UNITED STATES PATENT AND TRADEMARK OFFICE

APPLICATION NO.	FILING DATE	FIRST NAMED INVENTOR	ATTORNEY DOCKET NO.	CONFIRMATION NO.
10/517,883	12/29/2005	Michael Tittmann	502901-338PUS	1374
27799 7590 12/08/2009 COHEN, PONTANI, LIEBERMAN & PAVANE LLP 551 FIFTH AVENUE SUITE 1210 NEW YORK, NY 10176				
EXAMINER CHAUDRY, ATIF H				
ART UNIT 3753		PAPER NUMBER		
MAIL DATE 12/08/2009		DELIVERY MODE PAPER

Office Action Summary

DETAILED ACTION

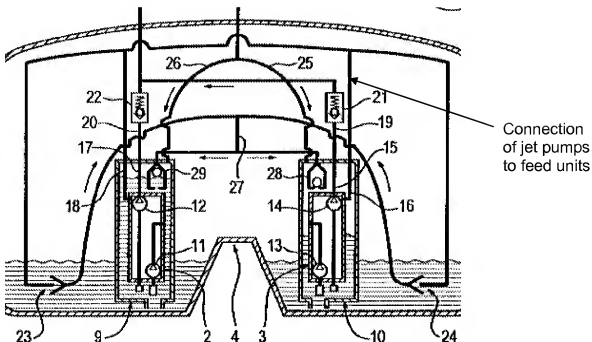
2. Claims 1-3, 5-7 and 9 are rejected under 35 U.S.C. 103(a) as being unpatentable over Sinz (US Patent 6276342) in view of Coha (US Patent 6553973).
3. Regarding claims 1 and 2, Sinz (fig. 1) discloses a fuel supply system for feeding fuel from a fuel tank 1 to an internal combustion engine 7 of a motor vehicle with a plurality of feed units 2, 3 arranged in the fuel tank 1, in which the feed units each have a surge chamber 9, 10 for collecting fuel and jet pumps 23, 24 for filling opposite surge chambers. Sinz fails to disclose a suction of a jet pump provided for filling a first surge chamber arranged in a second chamber. Coha (fig 1) teaches a fuel supply system comprising a saddle fuel tank and a plurality of surge chambers 69, 79 with the surge chamber 71 being fed by a suction line 74 connected to a jet pump 68 located inside a second surge chamber 69. It would have been obvious to a person having ordinary skill in the art at the time of the invention to have provided the fuel system disclosed by Sinz with a jet pump suction inside the surge chamber as taught by Coha in order to balance

the fuel level in the two chambers. Sinz discloses the fuel jet pumps at a minimum designated height in the tanks and it have been obvious that when placed inside the surge tanks the suction inlet of the jet pumps would be at a designated minimum height in the surge tanks. Moreover, all jet pumps stop pumping fluid when the filling level drops below the suction inlet of the jet pump.
